# I-65 Lane Widening, Part I

VALUE ENGINEERING STUDY

**I-65 Lane Widening between  
Tennessee State Line to Natcher Parkway**

**Final Report**

### SKETCH OF ORIGINAL AND RECOMMENDED DESIGN

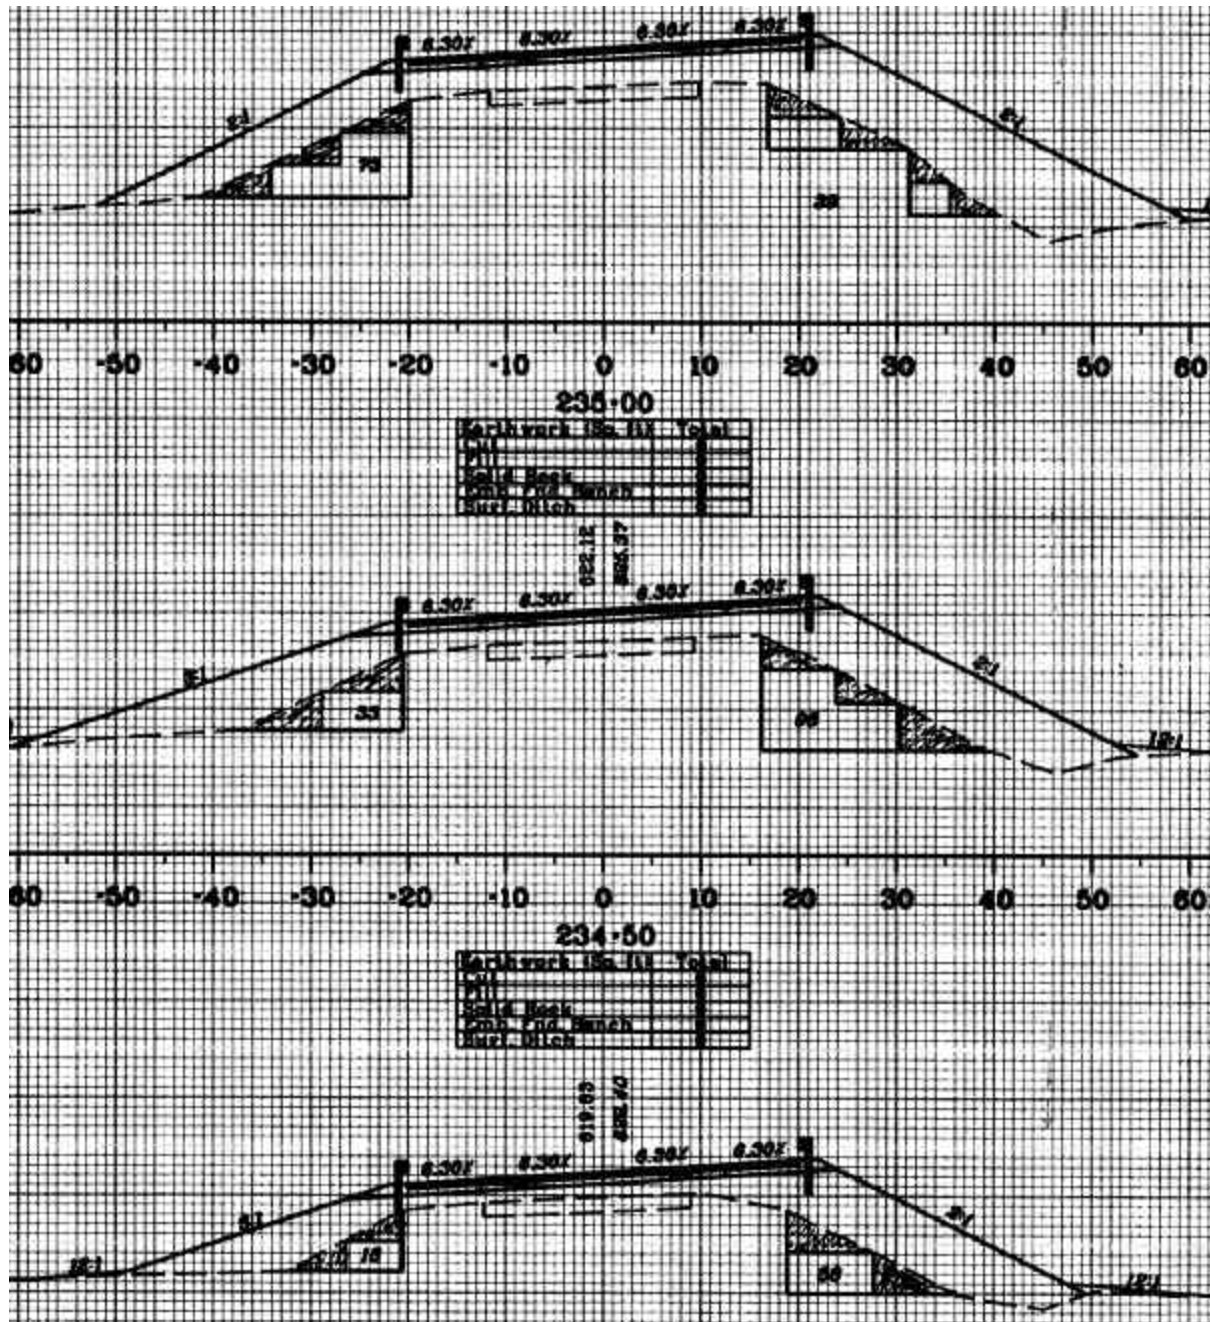
The benches on KY 240 should be reduced to a maximum height of 3 ½ feet to 4 feet.

The height of the benches should be reduced because it is neither safe nor practical to construct them to the height specified. A 3 ½ feet to 4 feet bench is all that is necessary to key the proposed fill into the existing embankment.

The attached sheet shows revised benches for stations 234+00 – 235+00. The reduction in excavation for these x-sections is 300sf (100sf average per x-section). The range of stations this applies to is 233+50 – 239+50 and 242+50 – 245+50 for a total of 900 feet.

SKETCH OF ORIGINAL DESIGN

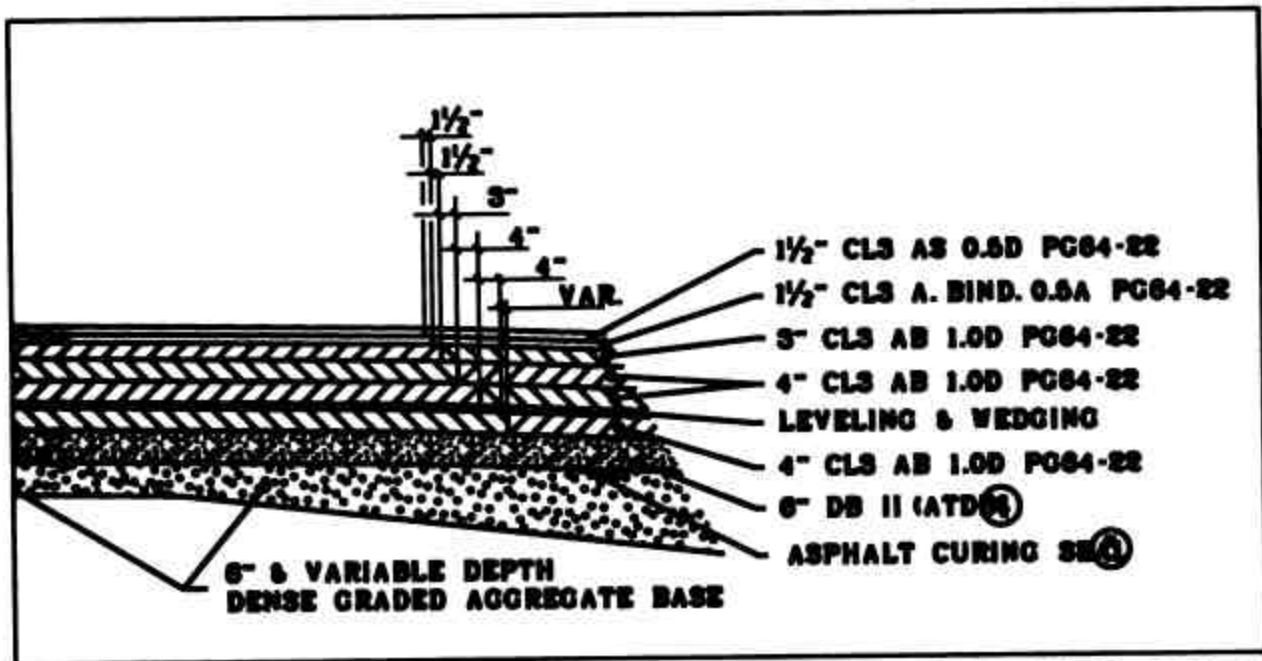
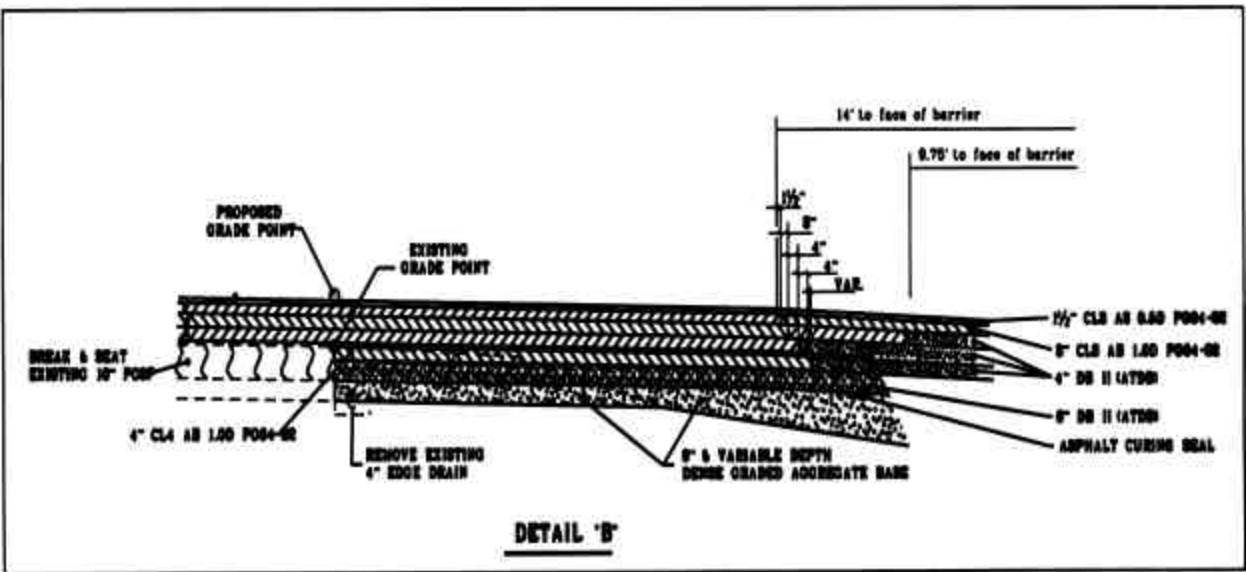
Substitute drainage blanket, ATDB, for the bottom 3 lifts of asphalt base on the inside shoulders.

It is not necessary to construct the inside shoulder to the same thickness of asphalt base as the driving lanes. It is proposed that the same pavement design for the outside shoulder be used for the inside shoulder. The portion of the inside shoulder that traffic will be running on should be constructed of two lifts (7") of asphalt base, but the rest of the inside shoulders can have a reduced asphalt base.

## SKETCH OF RECOMMENDED DESIGN

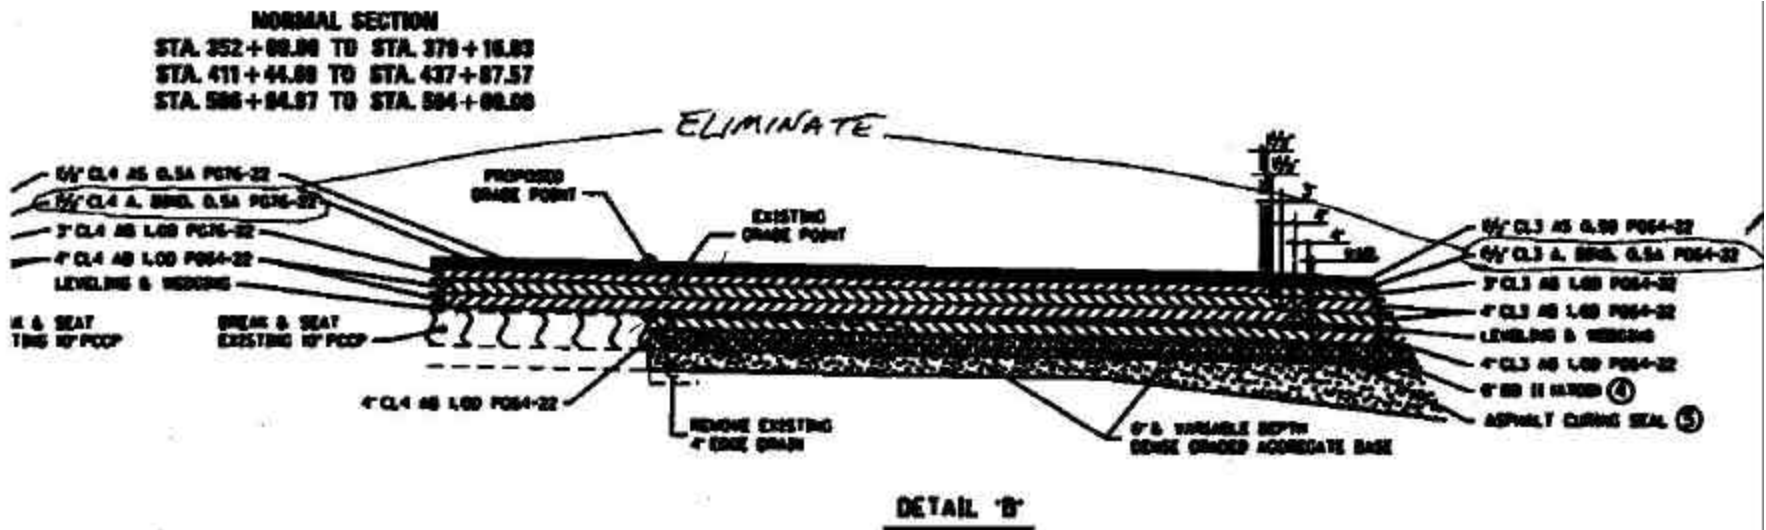
Eliminate 1 ½" layer of binder on sections 3, 4, and 5.

Extra materials and construction of the 1 1/2" binder is not justified, because the final 1 1/2" surface will provide an adequate finish and a smooth ride for motor vehicles.

## SKETCH OF ORIGINAL DESIGN

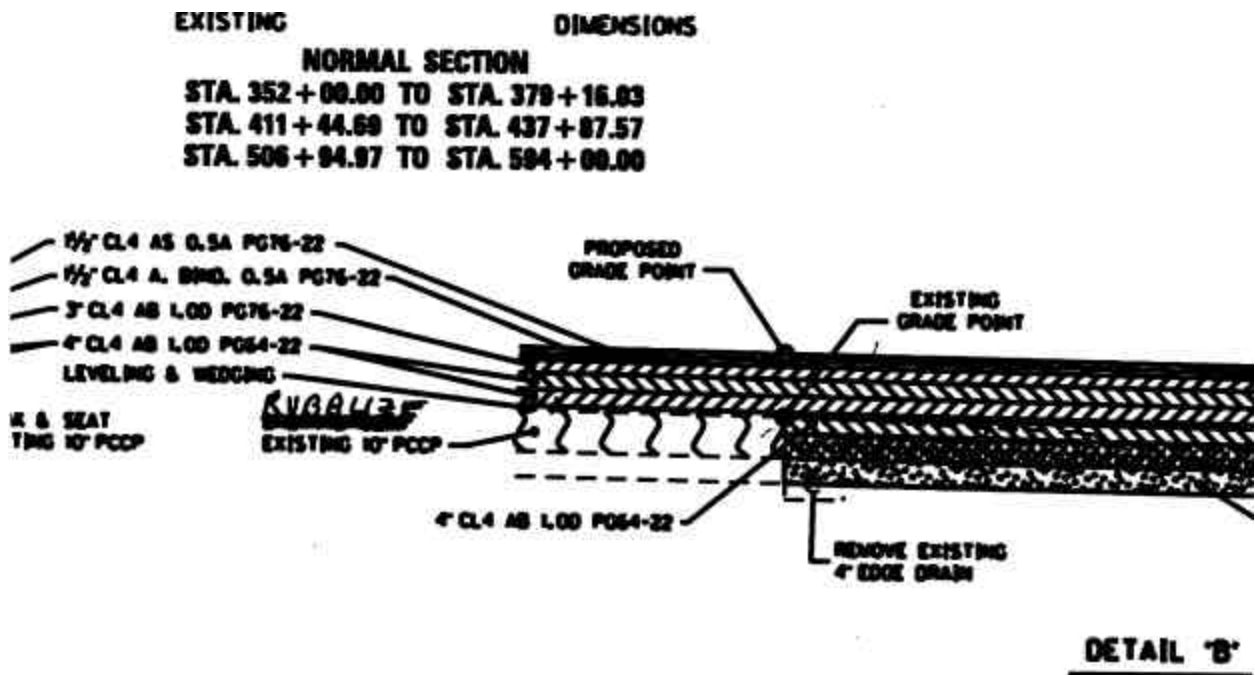
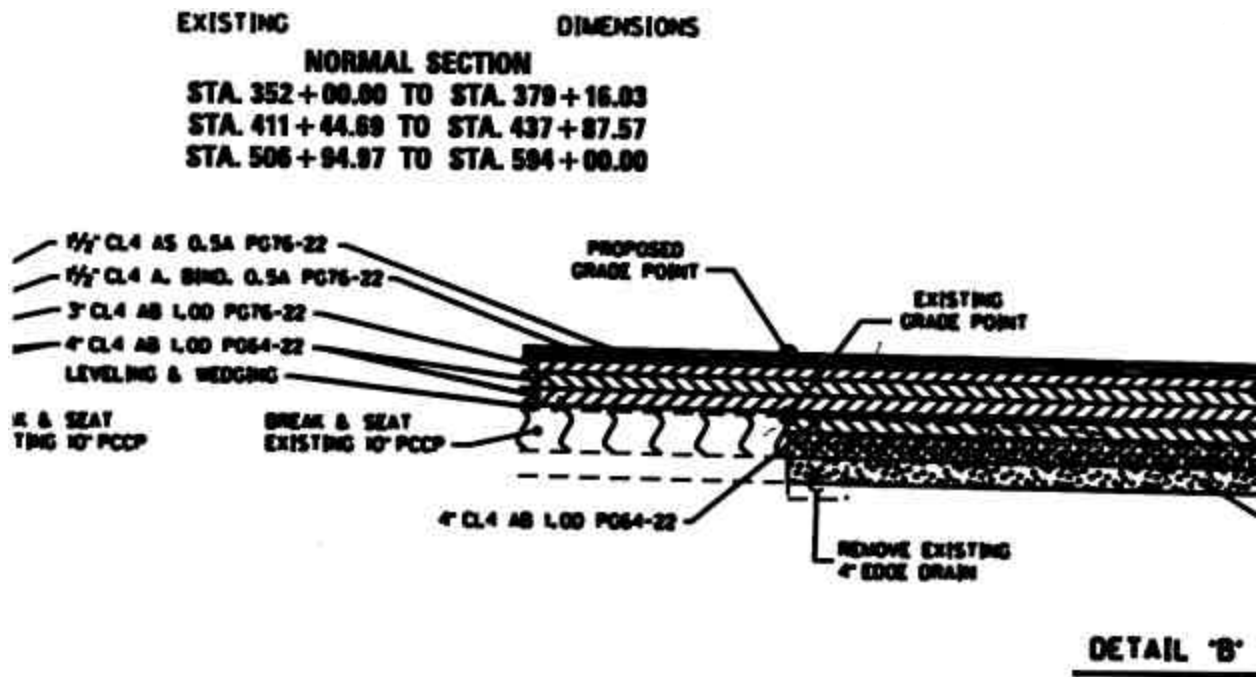
Break and seat the existing 10" PCCP in Section 5.

The VE team does was not given sufficient data to justify the using of the rubblization method in section 5, when the easier and faster method of break and seat would achieve acceptably comparable results.

SKETCH OF ORIGINAL DESIGN

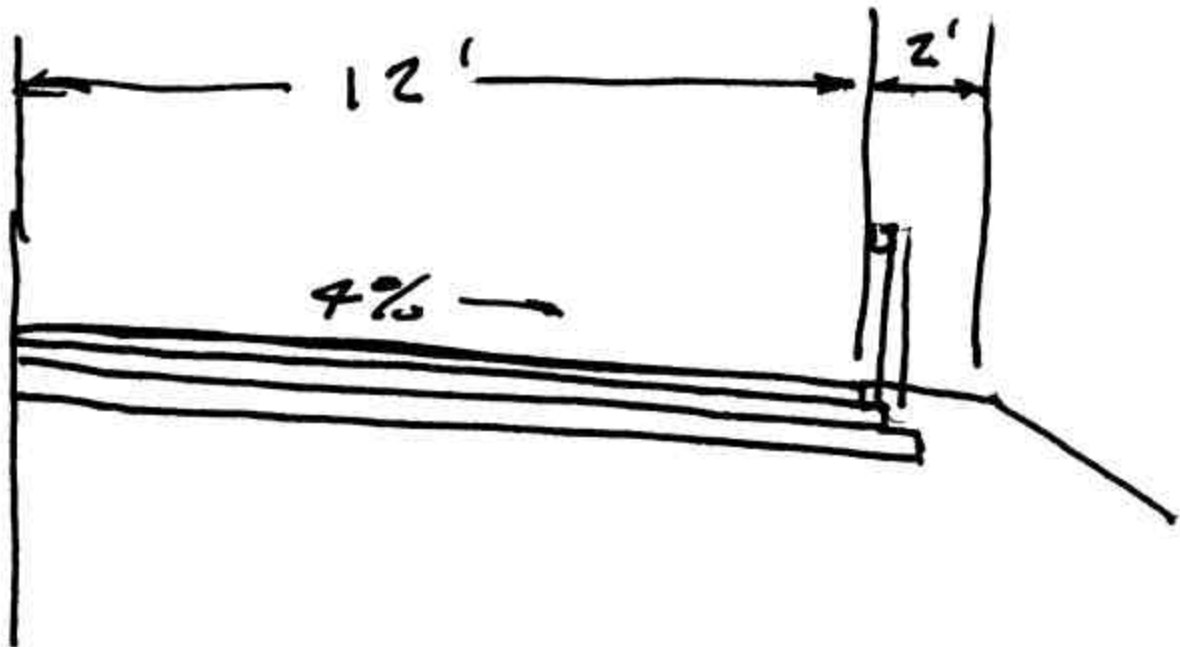
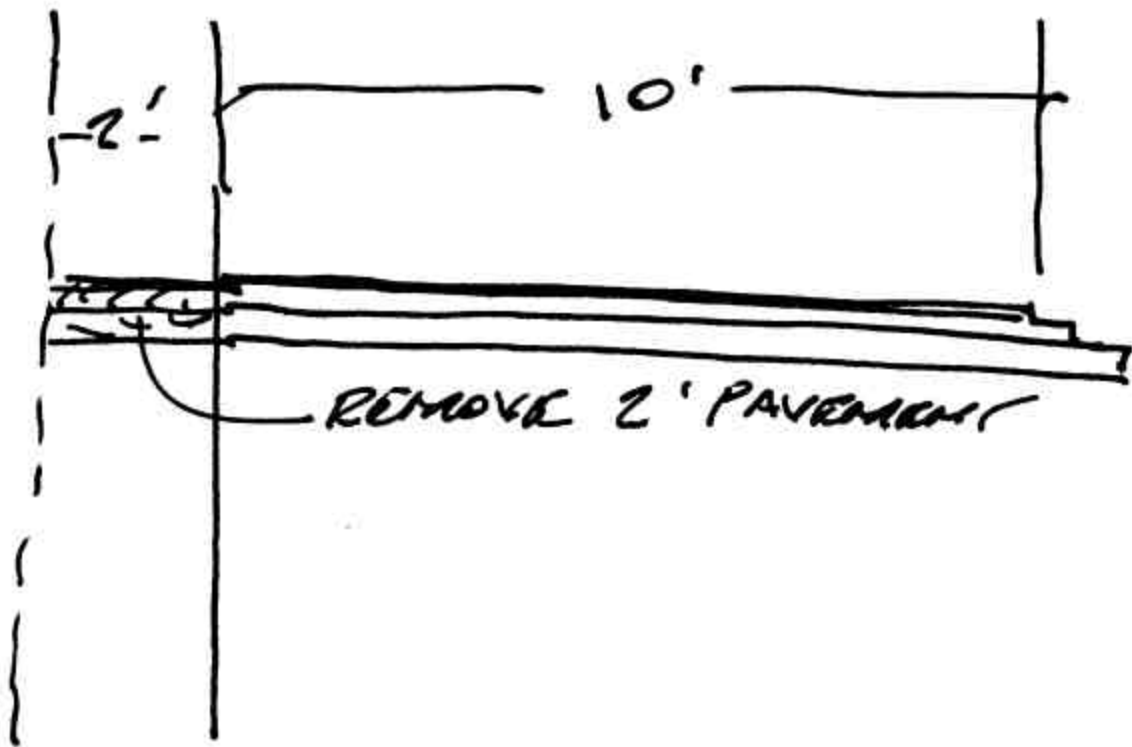
The outside shoulder width should be changed to only 10 feet.

Other states such as Tennessee use 10-foot shoulders, so they have been successfully used before. The 10-foot width meets AASHTO criteria, which indicates the additional width is not necessary.

## VALUE ENGINEERING DESIGN COMMENT # 8

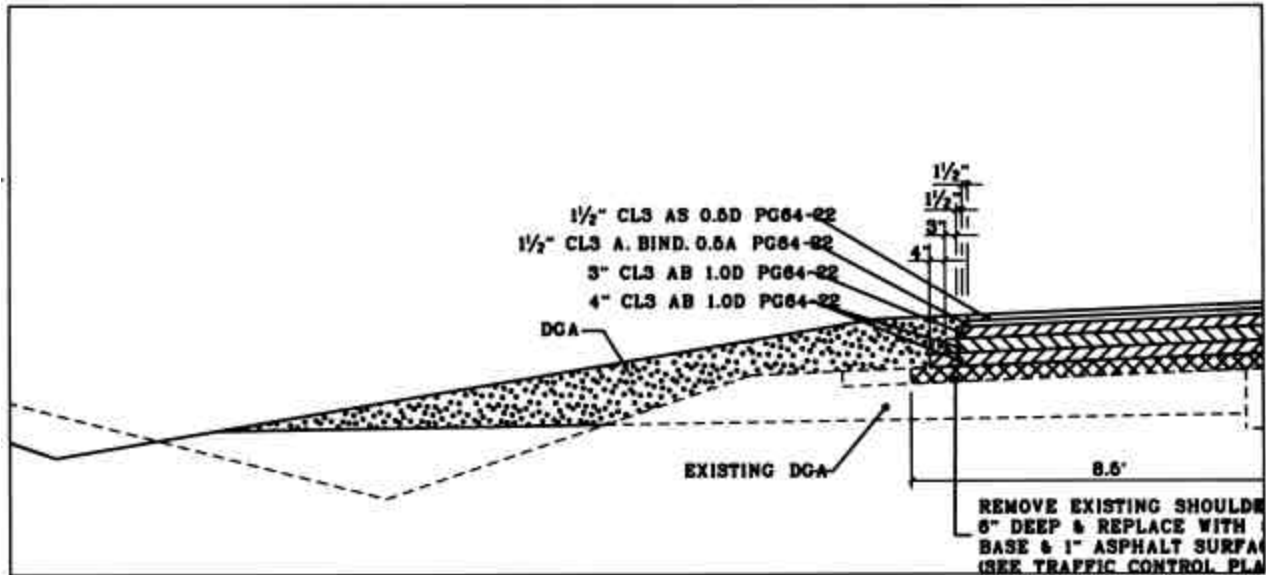
Construct DGA on the outside wedge to an elevation equal to the top of the existing shoulder. This is in lieu of constructing the outside wedge to the elevation equal to the bottom of the existing DGA under the shoulder.
